Portland General Electric Company

Trojan Nuclear Plant  
Docket 50-344  
License NPF-1

PGE Responses to the March 18, 1980 NRC Letter  
Regarding the Second 40-Month Inservice Inspection Program  
and PGE Responses to Additional ISI Items

Reference: 14" RH-601R-5-2 Residual Heat Removal Suction from Steam Generator

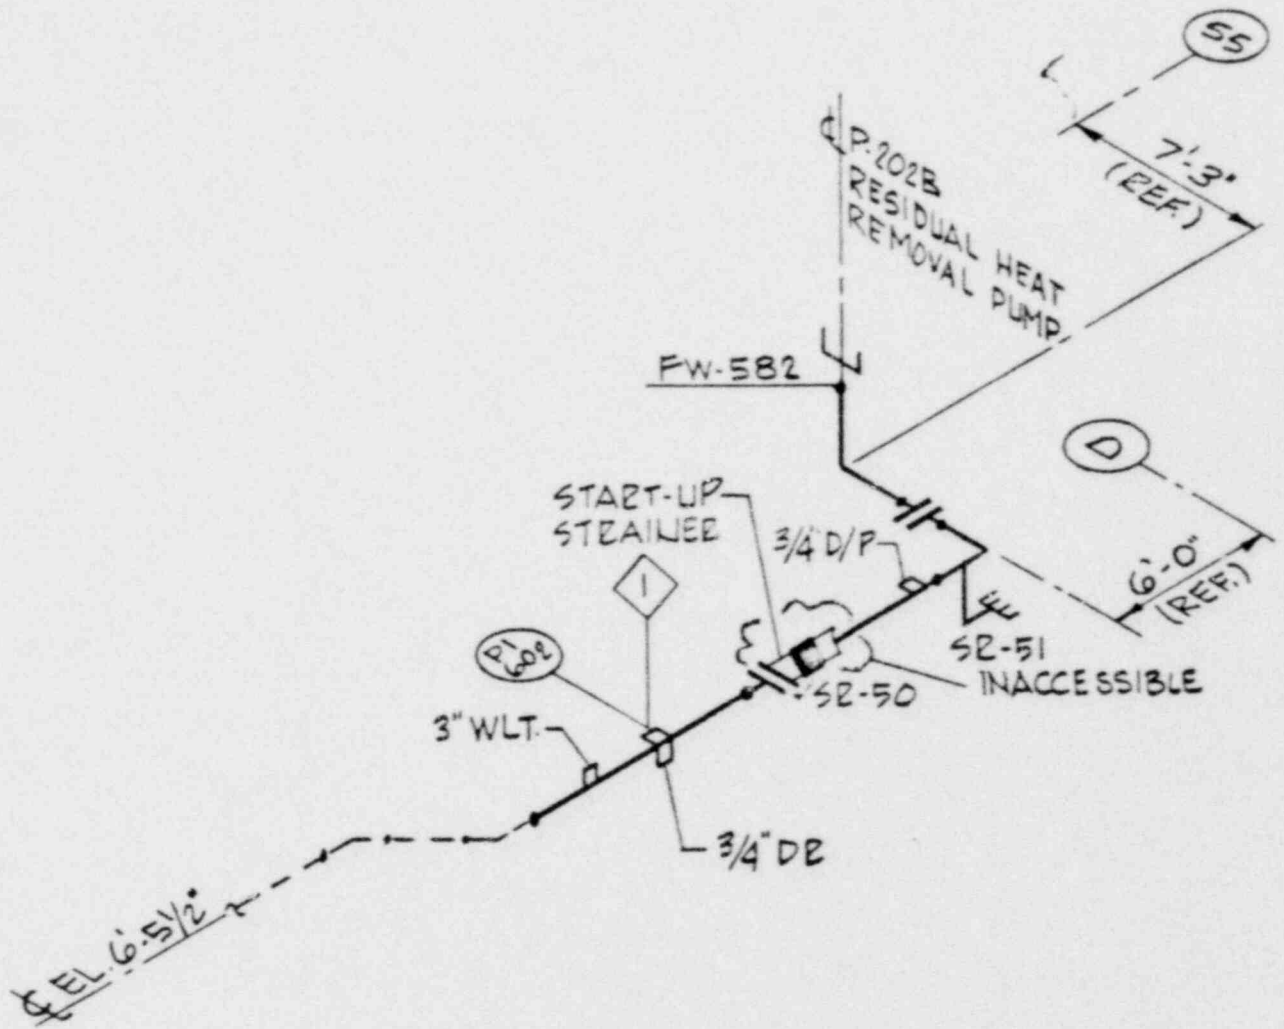
7. Relief 4.2.11. Please furnish drawings and/or details to show the inaccessibility of these welds.

The two welds were omitted from the preservice inspection program and alternative welds were examined. These welds would not require examination during inservice inspections unless the requirements of IWC-2430 came into effect. Drawings are attached which show the as-built condition of weld accessibility.
